17328 YOUNGBLOOD RD

CERTIFICATE OF COMPLETION/OPERATION PERMIT

RE: Property located at 17328 Youngblood Road 3
FILE: 4840A
PARCEL: 21708501 PO

PROPOSED PLOT PLAN

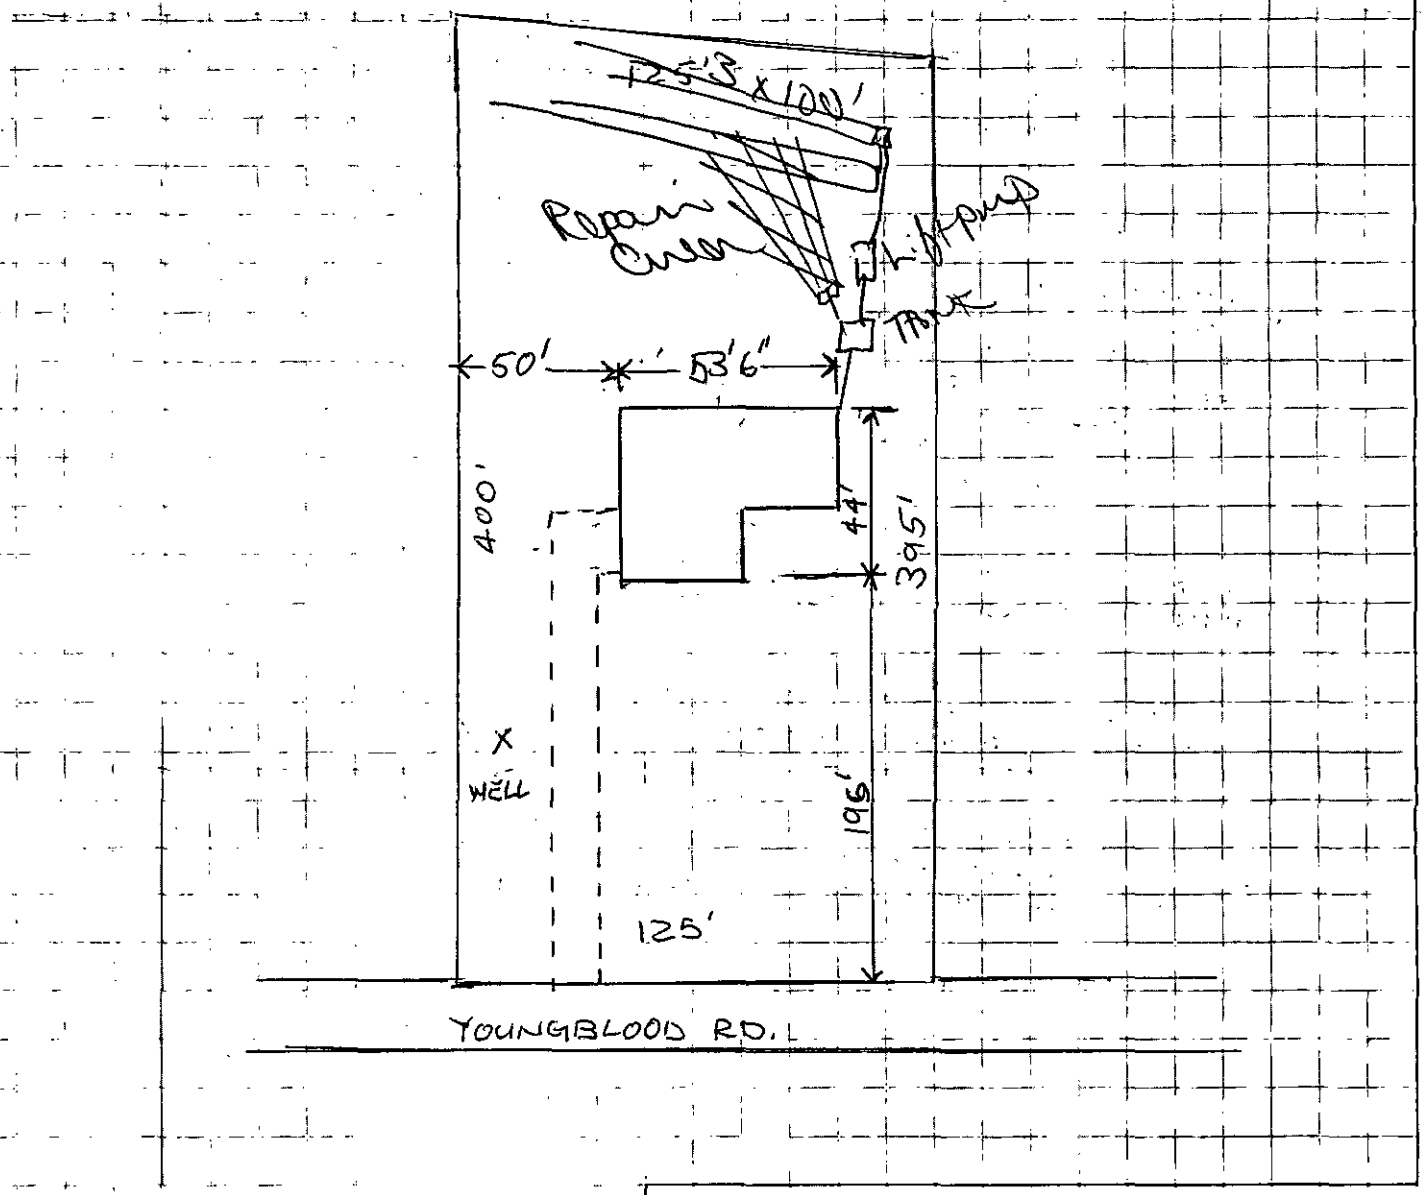
These lots are Marginal at best. Most of the Area has been eroded by farming and not much soil is left. Lot 1 appears to be out. Lot Two Two Some deep soils but The Slopes are bad. The other Three Might work With A Alternate System Such As A Shallow Trench.

MECKLENBURG COUNTY ENVIRONMENTAL HEALTH
SITE EVALUATION REPORT
SERIAL NUMBER 11945

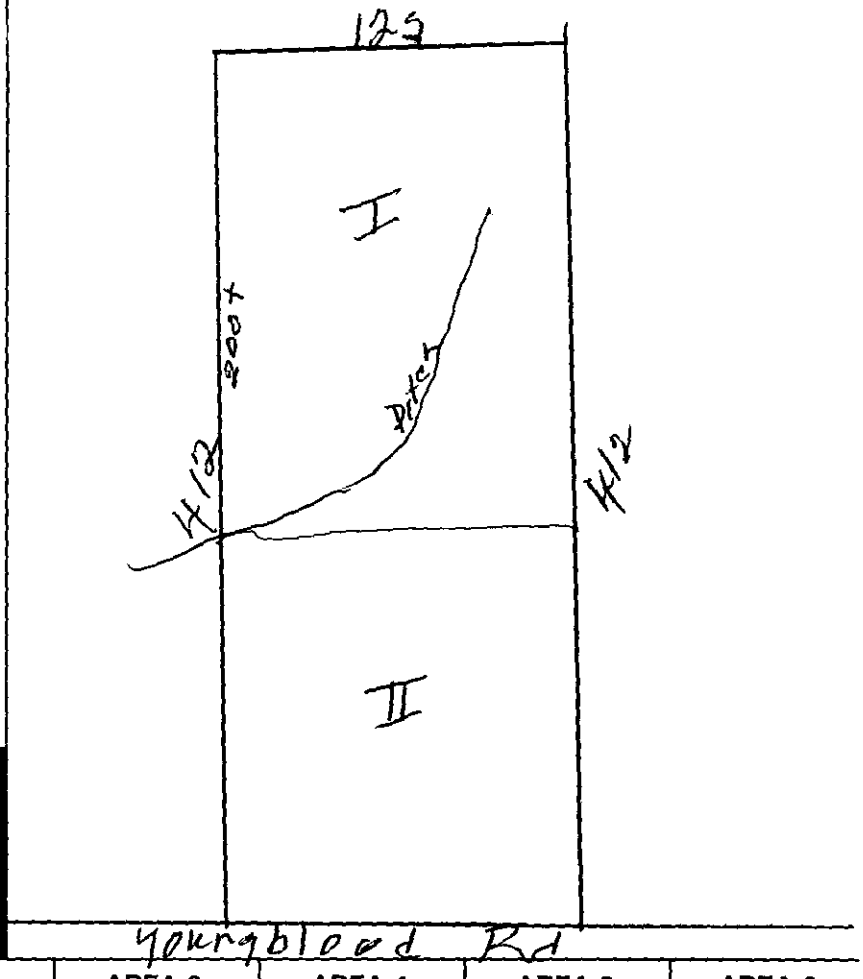
Comments: Lift Station Maybe Required Area Rated

FACTORS	AREA 1	AREA 2	AREA 3	AREA 4	AREA 5	AREA 6
Topography	S (PS) U 2-6	S (PS) U 2-7	S PS U	S PS U	S PS U	S PS U
Texture	S (PS) U	S (PS) U	S PS U	S PS U	S PS U	S PS U
Structure	S (PS) U	S (PS) U	S PS U	S PS U	S PS U	S PS U
Drainage	S (PS) U	S (PS) U	S PS U	S PS U	S PS U	S PS U
Depth	S (PS) U 48+43"	S PS (U) 24-36	S PS U	S PS U	S PS U	S PS U
Restrictive Horizons	S (PS) U	S (PS) U	S PS U	S PS U	S PS U	S PS U
Available Space	S (PS) U	S (PS) U	S PS U	S PS U	S PS U	S PS U
Other (specify)	S PS U	S PS U	S PS U	S PS U	S PS U	S PS U
Soil Group/Series	IVa Cecil	IVa Appling Lkd				
Area Classification	S (PS) U	S PS (U)	S PS U	S PS U	S PS U	S PS U

MECKLENBURG COUNTY ENVIRONMENTAL HEALTH
SITE EVALUATION REPORT
SERIAL NUMBER 15487

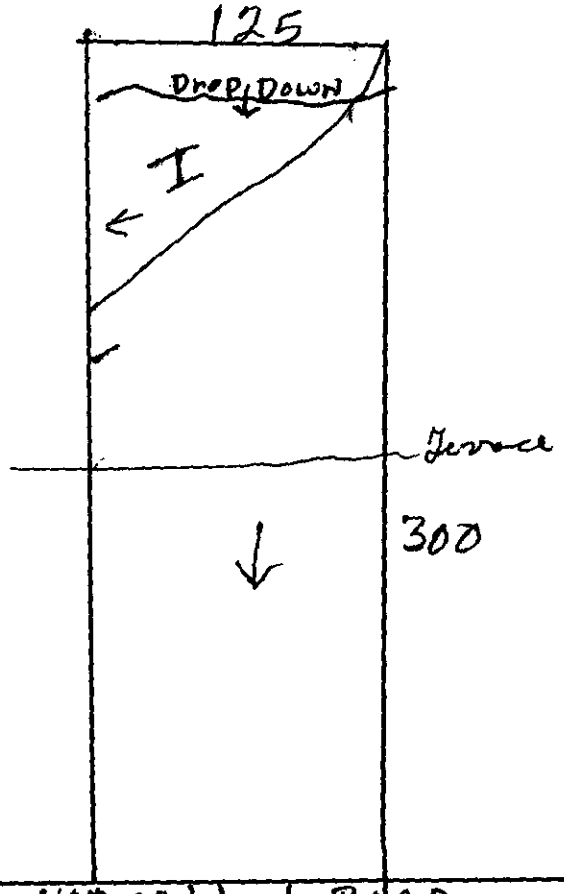
FACTORS	AREA 1	AREA 2	AREA 3	AREA 4	AREA 5	AREA 6
Topography	S (PS) U 2-6	S (PS) U 2-6	S PS U	S PS U	S PS U	S PS U
Texture	S (PS) U	S (PS) U	S PS U	S PS U	S PS U	S PS U
Structure	S (PS) U	S (PS) U	S PS U	S PS U	S PS U	S PS U
Drainage	S (PS) U	S (PS) U	S PS U	S PS U	S PS U	S PS U
Depth	S (PS) U 30-45	S PS (U) 24-36	S PS U	S PS U	S PS U	S PS U
Restrictive Horizons	S (PS) U	S (PS) U	S PS U	S PS U	S PS U	S PS U
Available Space	S PS (U)	S (PS) U	S PS U	S PS U	S PS U	S PS U
Other (specify)	S PS U	S PS U	S PS U	S PS U	S PS U	S PS U
Soil Group/Series	IVa Cecil	IVa Appling Like				
Area Classification	S PS (U)	S PS (U)	S PS U	S PS U	S PS U	S PS U
